MARK	DATE	DESCRIPTIONS	BY	CH'D	CCO#
0	05/04/07	W2 CAP BEAM ISD RESOLUTION	JD	AS	34S1

SAN FRANCISCO OAKLAND BAY BRIDGE
EAST SPAN SEISMIC SAFETY PROJECT
SELF-ANCHORED SUSPENSION BRIDGE
(SUPERSTRUCTURE & TOWER)

W2 CAP BEAM REINFORCEMENT DETAILS NO. 13A

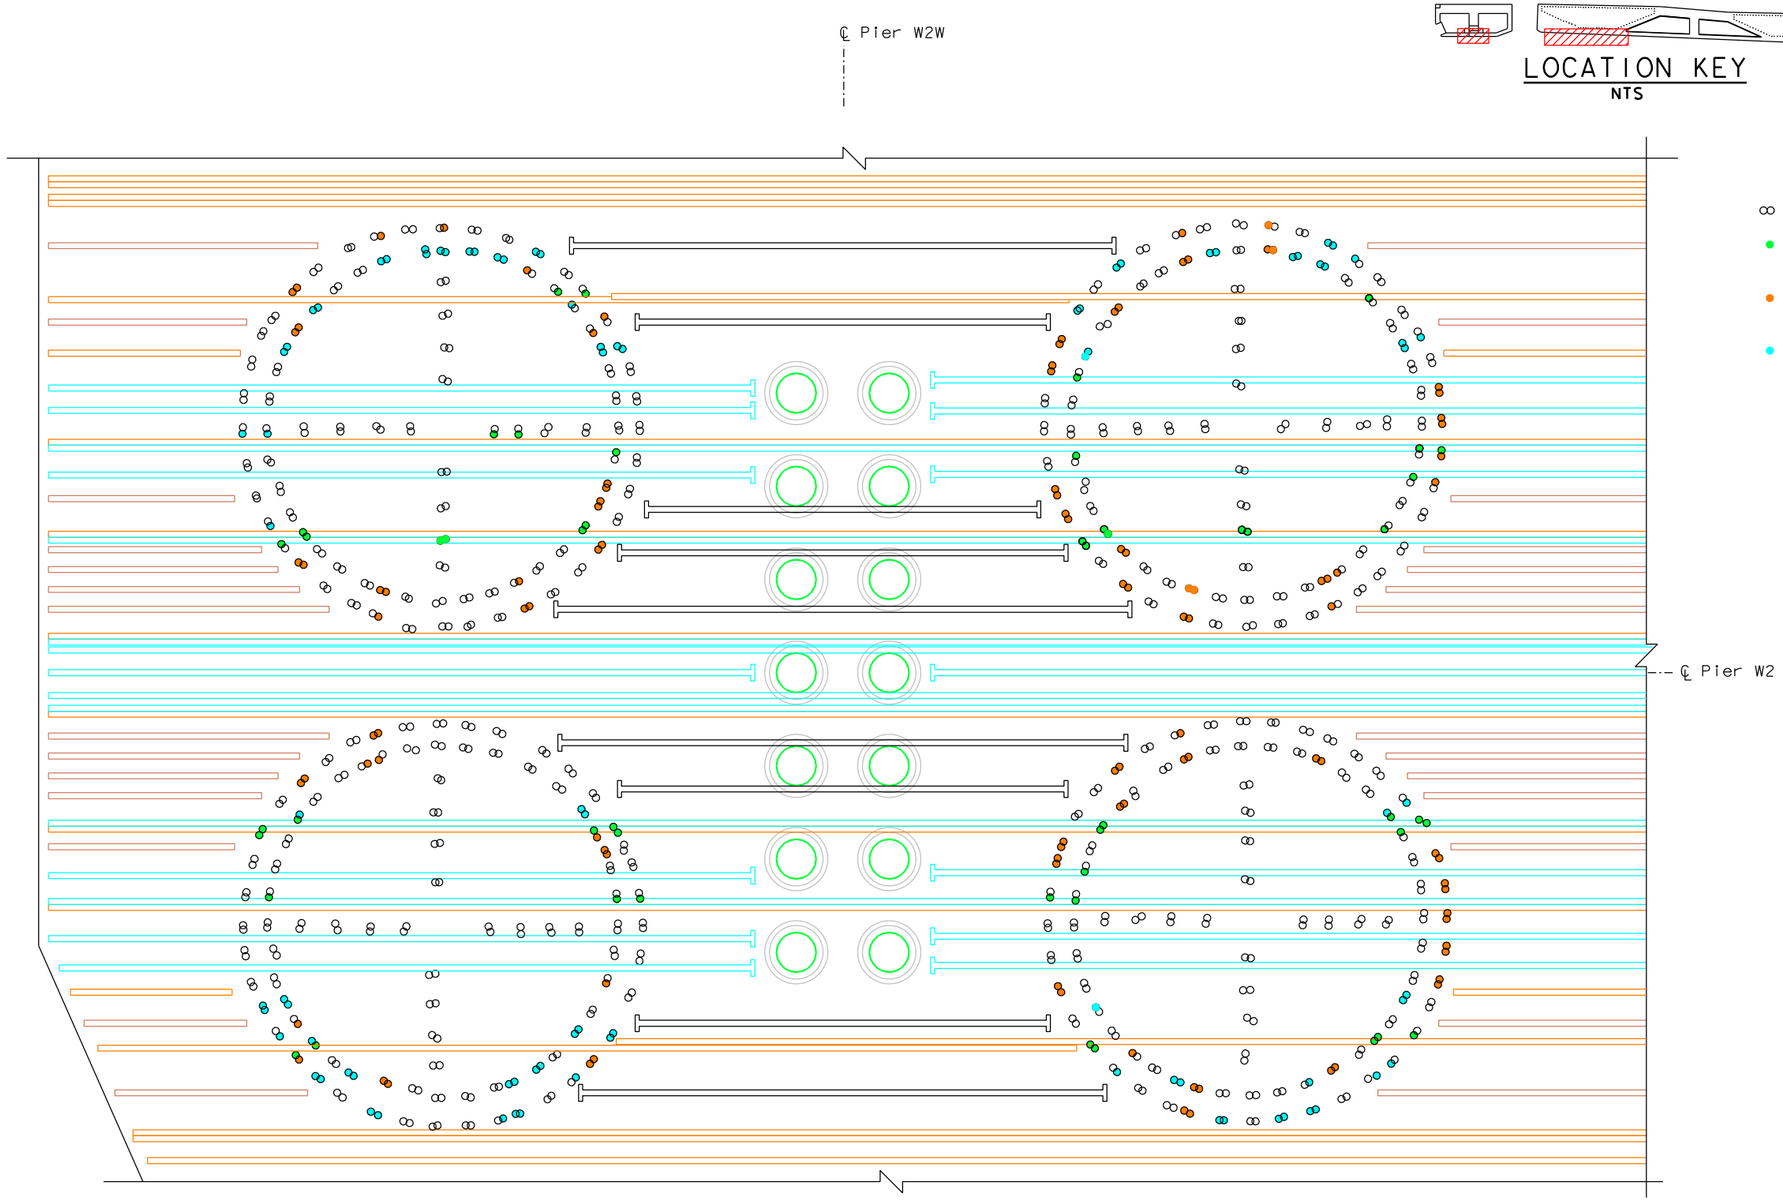
1. Transverse bottom mat reinforcement layout reflects as-surveyed vertical pier reinforcement locations within Region 4. The revised layout reflects anticipated column reinforcement cut-offs based on the survey data provided by the Contractor.

9. Prior to cutting any column reinforcement, the Contractor is required to submit locations and number of bars to be field cut for Engineer's review and approval.

7. Adjust reinforcement as required to clear column reinforcement.
8. Field cut #43 column reinforcement bundles shall be fitted with a single field-installed round headed anchor.
